MILITARY SPECIFICATION

CHARGER, BATTERY: 10541243

This amendment forms a part of Military Specification MIL-C-60299A(MU), dated 18 June 1970.

FIG. 1

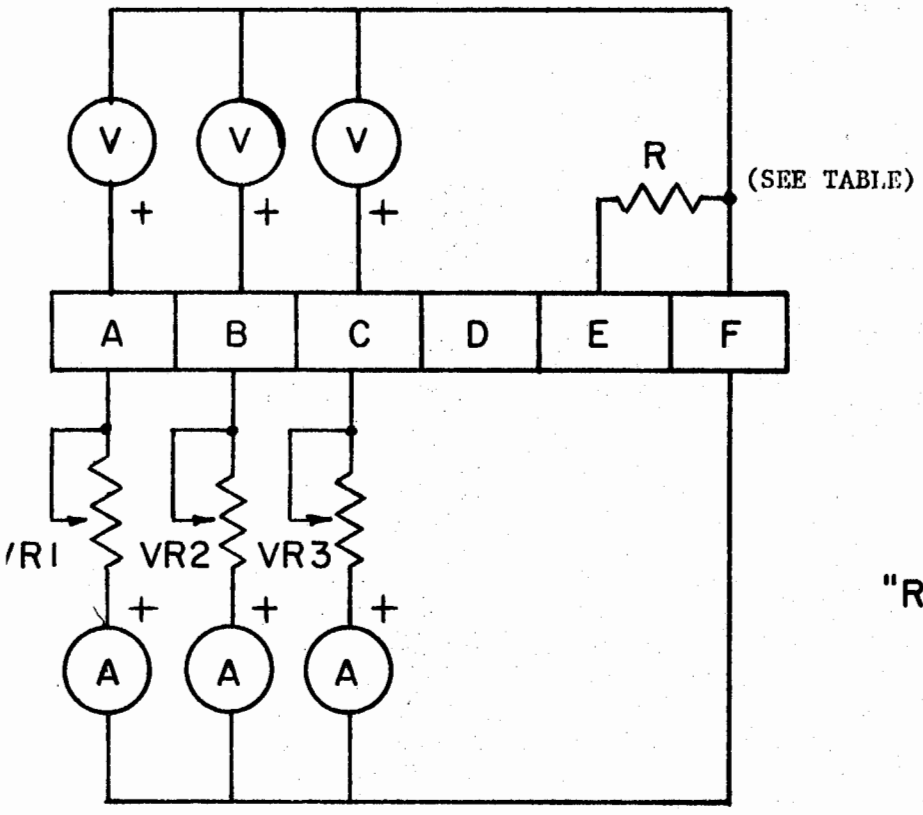
Figure 1: Delete lines connected to pin "D"; connect lines to pin "F".
